Access Compliance Report

Public Rights-of-Way

(Curb Ramps)

Intersection ID: 10003849	Main Street: DIXIE_RIVER_RD	Cross Street: NEW_FASHION_WY	Location: NW
ADA ID: A0DBE23C79BA	Ramp Type: Perp	Initial Pass/Fail: Fail	Overall Compliance: No
			Severity Score: 21.25

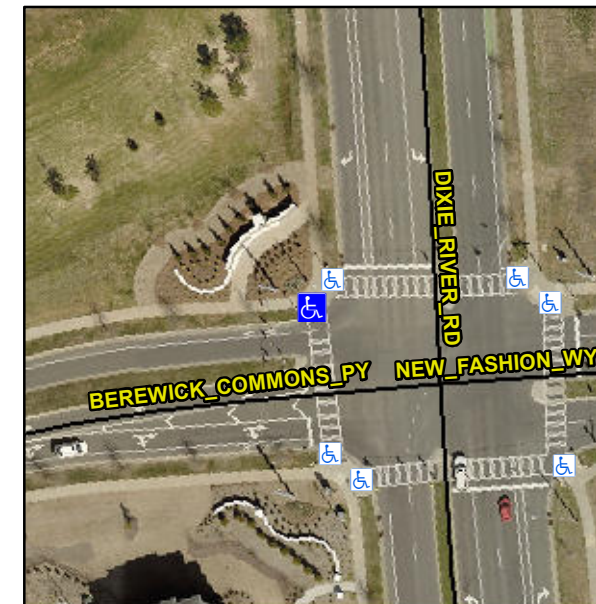
R304.5.1, R304.2.2

Compliance	Description	Data	Compliance	Description	Data
N/A	Ramp Length (in)	72.0	No	Ramp Slope (%)	8.7
No	Ramp Width (in)	46.0	Yes	Ramp XSlope (%)	1.3
N/A	Flare Type LT	N/A	N/A	Flare Type RT	N/A
N/A	Flare Slope LT (%)	N/A	N/A	Flare Slope RT (%)	N/A
N/A	Flare Traversable LT?	N/A	N/A	Flare Traversable RT?	N/A
N/A	Landing Length (in)	N/A	N/A	DWS Provided?	N/A
N/A	Landing Width (in)	N/A	N/A	DWS Contrast?	N/A
N/A	Landing Slope (%)	N/A	N/A	DWS Length (in)	N/A
N/A	Landing X Slope (%)	N/A	N/A	DWS Full Width?	N/A
N/A	Landing Curb? (Y/N)	N/A	N/A	DWS Offset (in)	N/A
N/A	Shared Landing?	N/A			
N/A	Gutter Ponding?	N/A	N/A	Gutter Slope (%)	N/A
N/A	Gutter Lip Ht (in)	N/A	N/A	Gutter X Slope (%)	N/A
N/A	Painted X Walk1?	Yes	N/A	Painted X Walk2?	N/A
	X Walk 1 Direction	To S		X Walk 2 Direction	N/A
N/A	X Walk 1 Width (in)	110.0	N/A	X Walk 2 Width (in)	N/A
	X Walk 1 Slope (%)	2.7		X Walk 2 Slope (%)	N/A
	X Walk 1 X Slope (%)	0.3		X Walk 2 X Slope (%)	N/A

Remove & Replace Entire Ramp.
